RE: Parker and Pine F1 L1: In-N-Out Burger
Formal Site Plan Application – 1st Submittal Review Comments – SP22-143
Fire & Life Safety

Plan Review Summary:

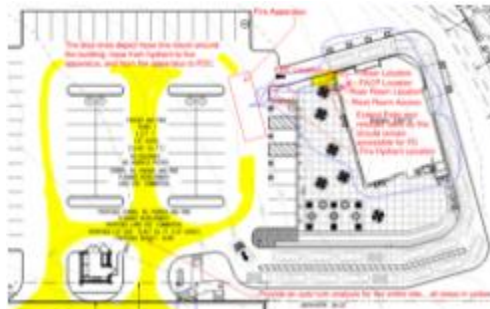
5. The applicant shall provide a room layout that (in advance of a plan set for the commercial building permit) to ensure that the riser room is sized appropriately. With regard to the fire sprinkler control valve room, ensure that the following is addressed:

- The FACP will be required to be located on an interior wall in the fire sprinkler control valve room; ensure that the riser room is sized to accommodate the FACP and the riser. A three-foot clearance is required in front of the FACP as well as the sprinkler riser.

Response: The riser room detail on Sheet WS1.0 identifies the FACP location, sprinkler riser location, and 3' clearance in front of both.
 - The underground shall enter the building and turn up no further than 24 inches from foundation wall; three feet of clearance is required in front of the fire riser with a minimum of 12" of clearance behind the riser and 18" to each side of the riser.

Not satisfied; while the applicant has indicated that "a fire riser room has been added to the plans to show proper clearances and access as necessary", the applicant has not identified which plan set the detail has been provided on (as required in the directions at the beginning of this letter). I have checked the PWSD CE Plan Set, the INOB Site Plan Set, and the Town CD Plan set... finding nothing. To note, I did find the layout of what is to be located in the trash surround on multiple pages. When resubmitting, provide the required documentation addressing the issues as noted here and, in the instructions, above.

Response: A fire riser room layout detail has been added to the bottom right corner of Sheet WS1.0 of the PWSD utility plan set to show proper clearance and access as necessary.
